Re: Pio Pico Energy Center Project (11-AFC-1)
Applicant's Responses to Staff's Data Requests, Set 1 (#1-59)

Response to CEC Data Request Set #1, 11-AFC-01

Submitted to the
California Energy Commission
July 2011

ALTA CONSULTANTS
 PLANNING ENGINEERING SURVEYING
 4901 Morena Blvd., Ste. 409 San Diego, CA 92117 (858) 581-6101 Fax (858) 581-6138
 JOB NO. 104-111, DATED MARCH 14, 2011

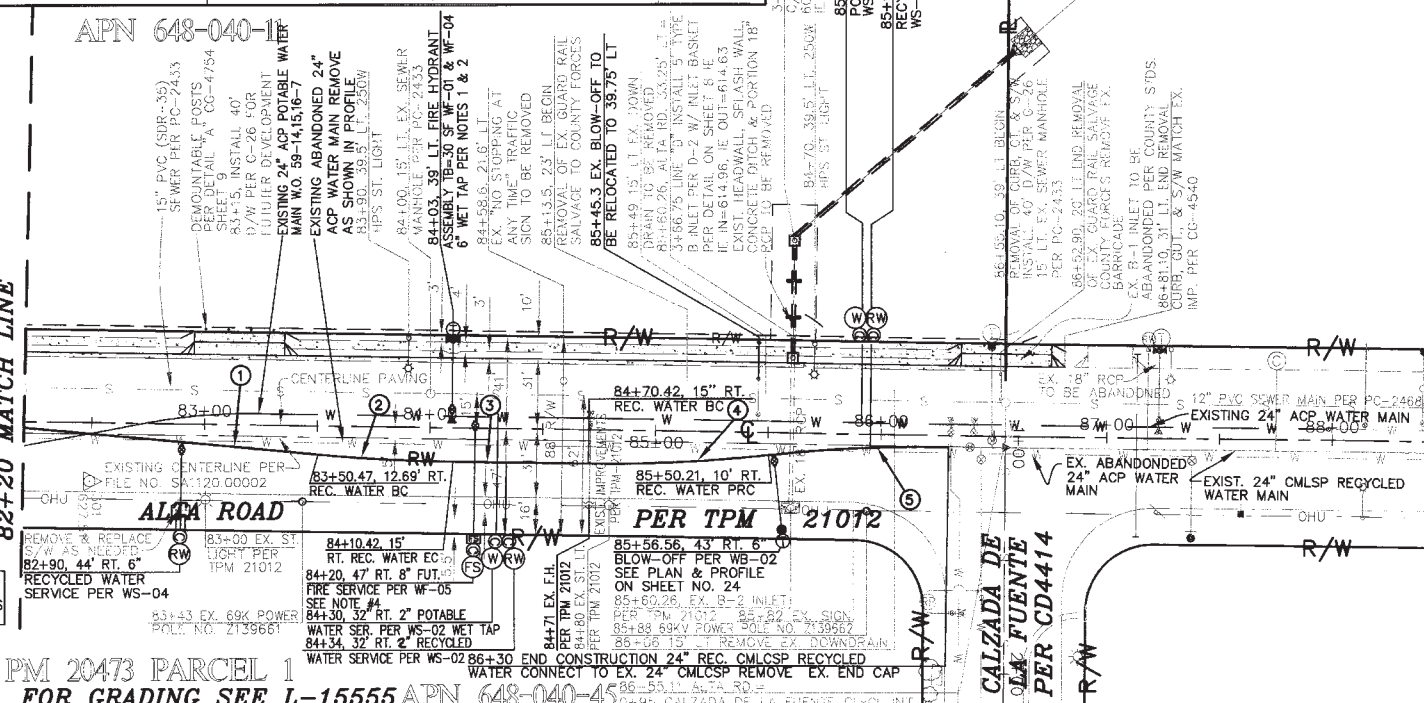
Sewer Pipeline, Storm Water Line, and Water Supply Line: Please depict the locations of the connections for these facilities on Figure 1-2, or provide an additional figure that depicts the locations of these connections, relative to the project site and the facilities to which they will be connected.

shown on the attached Exhibit 3, Alta Consultants drawing CG-4754 Sheet 23. Excavation depths to connect to the lines are approximately 3 feet for the water lines and 10 feet for the sewer line. The storm water line is already installed from the onsite retention pond to piping in Calzada De La Fuente as part of the land developer's grading and drainage plan.
